NOTICE OF MEETING
PLANNING AND ZONING COMMISSION
6:00 P.M. – July 15, 2021

PLANNING AND ZONING COMMISSION ITEM:
PC-21-10
Master Development Plan (MDP)
Goldsmith Tract

SUBJECT: Goldsmith MDP Review No.2
PC-21-10

CS100

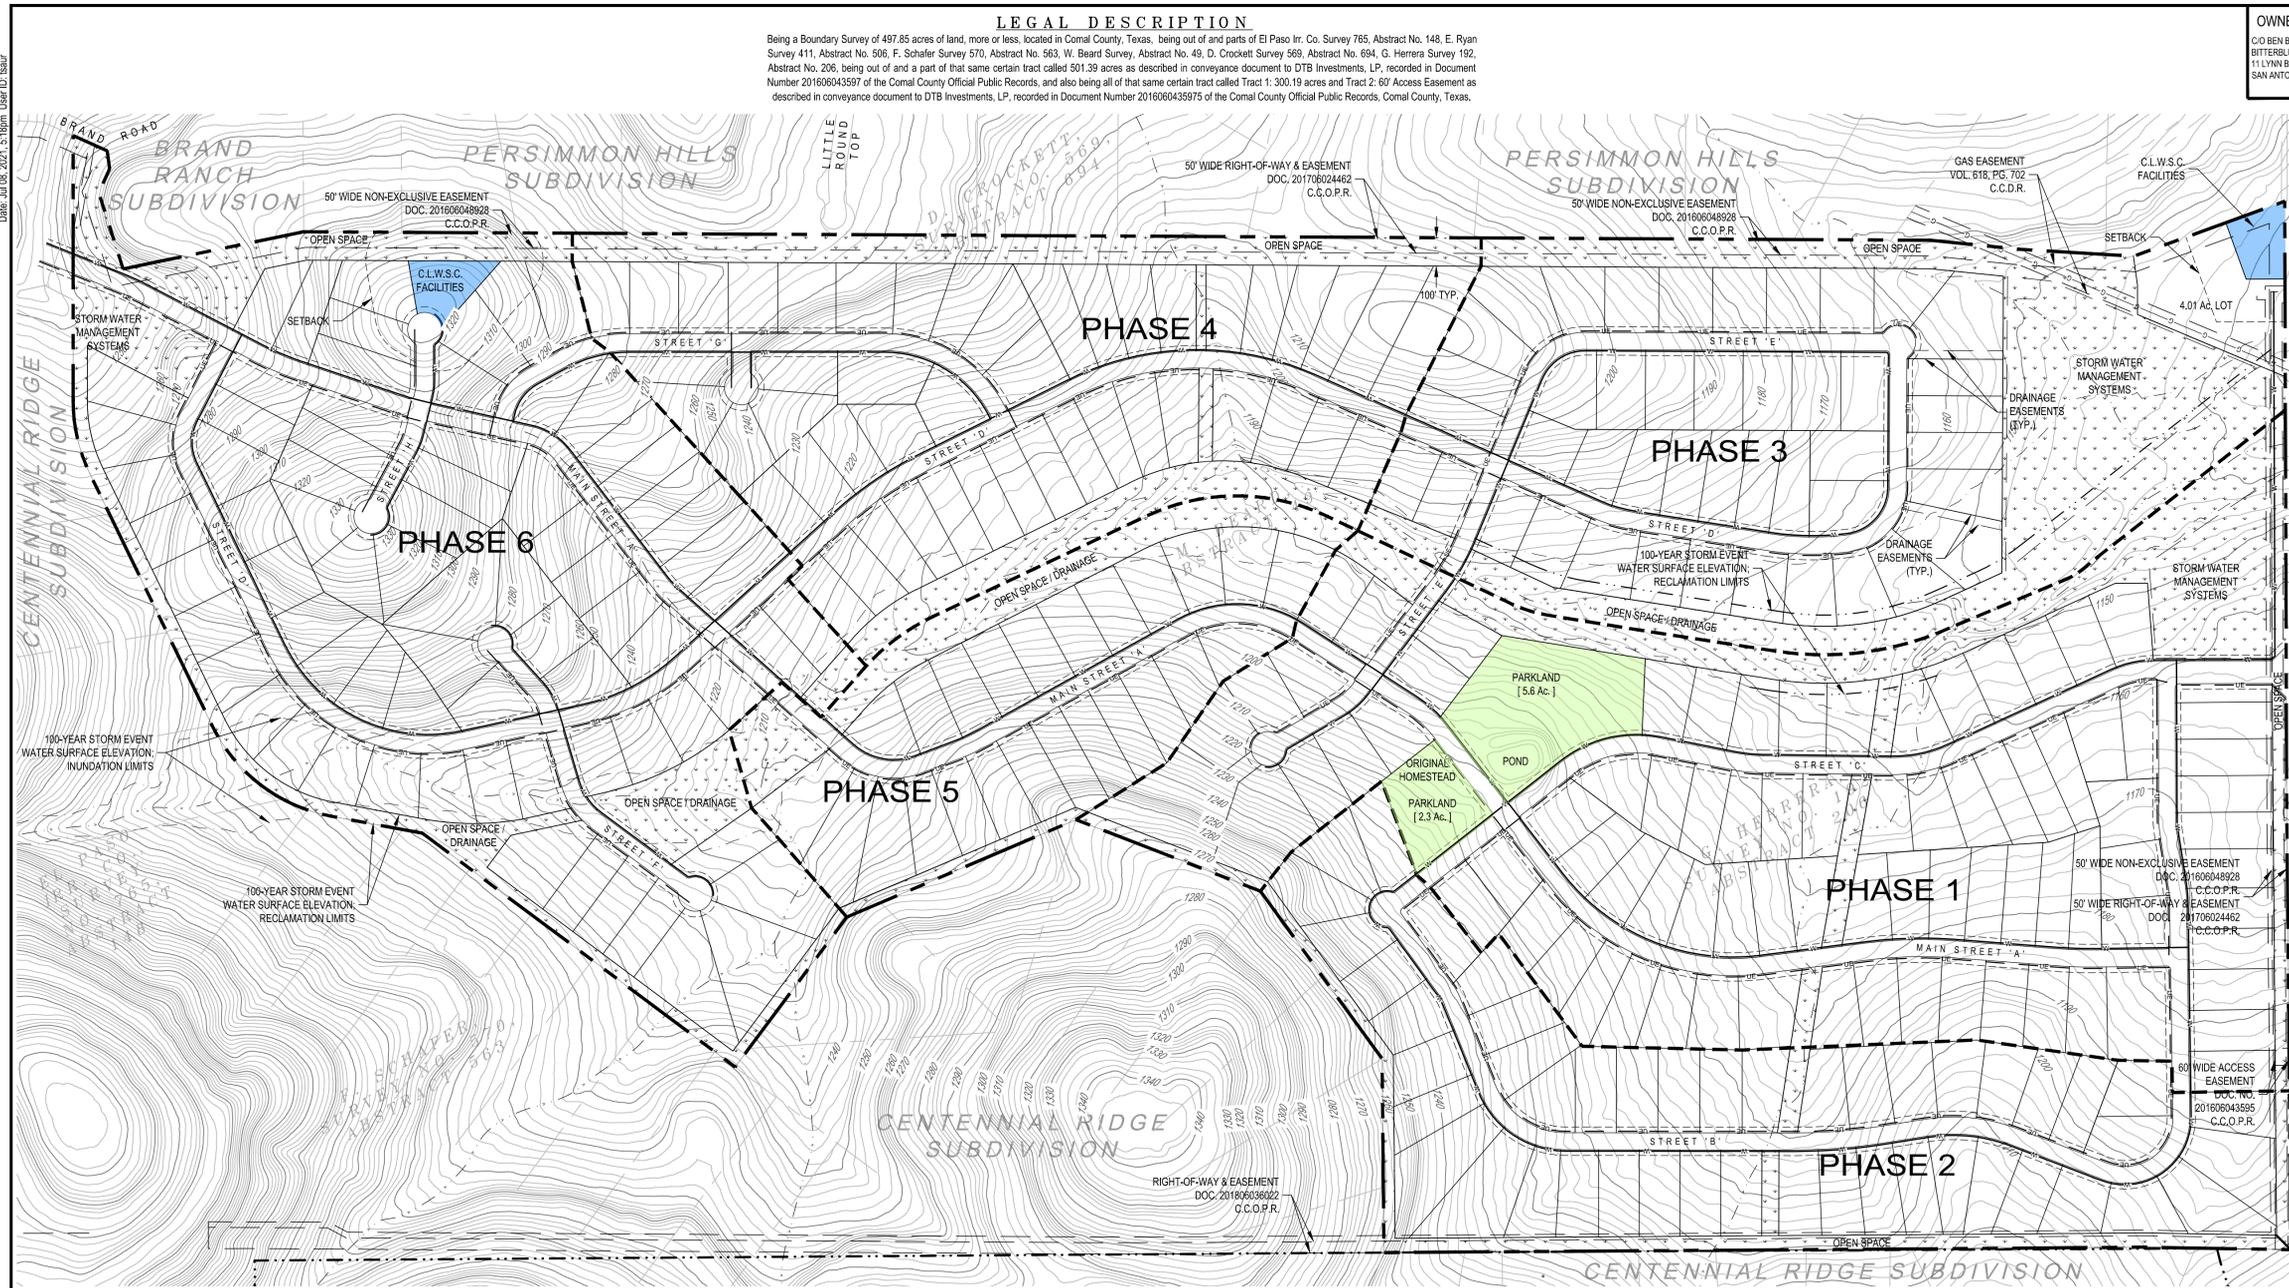
REVIEW COMMENT:
 Property area, lot count, & density doesn't match what is shown in 'LAND USE "R-2" SUMMARY'.

7. Boundary of development should be indicated with heavy lines. – [Comment resolved](#)

Ammann and Bulverde

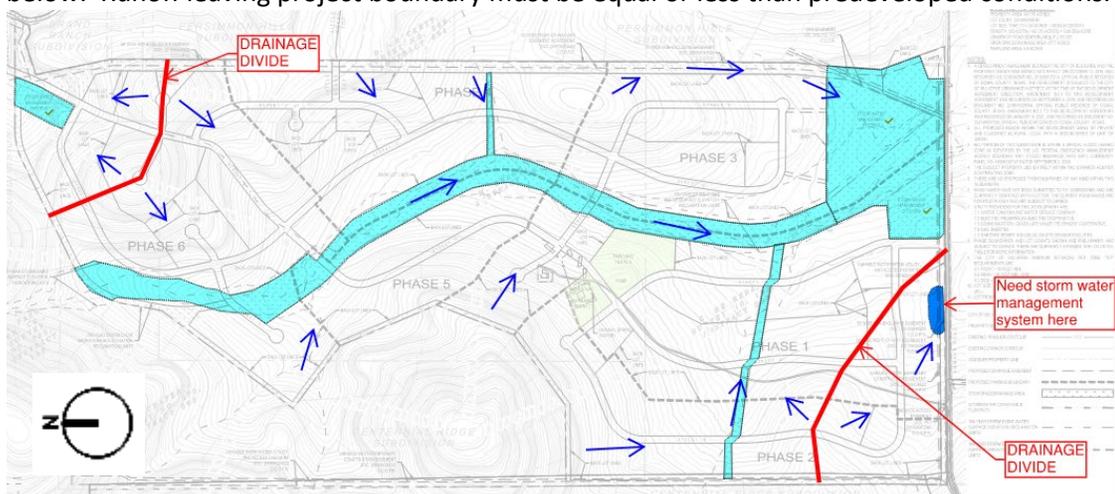
12. The existing WB RTL went into a school. While Comal ISD sold it, it's still titled as a school. From what we know, and the information presented, it is not clear that the existing RTL is no longer needed. Before we can accept the recommendation to remove the existing turn lane, study of the existing use of the turn lane and coordination with the current owner regarding their plans for the site is required.

13. Generally, we require use of Table 3-3 (not 3-3A) for turn lane deceleration lengths. However, given this is approaching a T-intersection, I believe use of 3-3A is acceptable in this case.

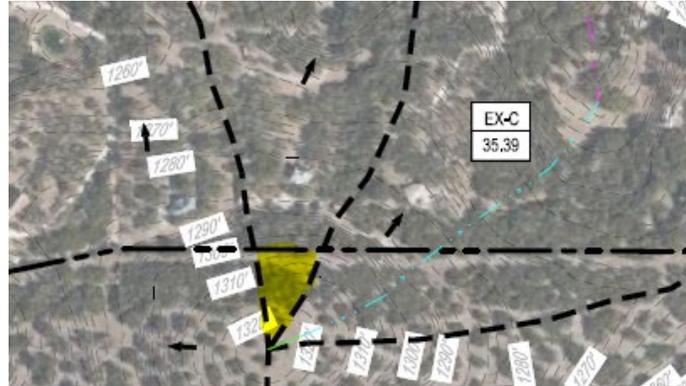
1. As noted in the previous comments on the Master Drainage Plan, an additional “Storm Water Management System” (i.e. detention) will be needed for the southwest drainage area as shown below. Runoff leaving project boundary must be equal or less than predeveloped conditions.

2. A portion of the proposed project site is not incorporated into any delineated drainage area. Please include the portion missing between drainage areas C and D (see yellow highlighted circled area).

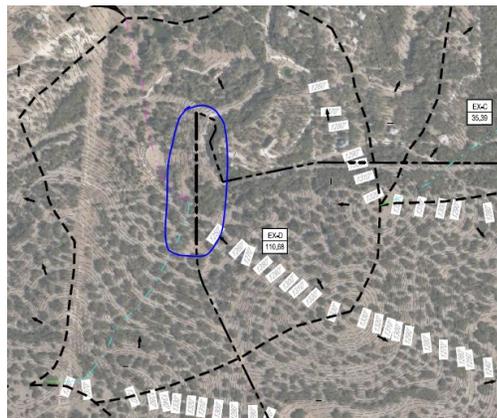
3. The impervious area proposed is in line with the TR-55 guidelines, however, if the final home sizes (and therefore impervious cover) will vary significantly from the 20% proposed, the runoff values should be recalculated. In addition, roadways and other impervious structures were not accounted for in the proposed conditions land use calculation.
4. The curve numbers selected do not align with the categories of curve numbers given in the City's Drainage Manual (Table 4.1).
5. It is difficult to discern the property boundary from the drainage area boundaries based on the line type used. Please differentiate between the two on the existing conditions map, similar to what was done for proposed. Also note that the line weight is heavier than it should be by EX-D (see blue circle below).
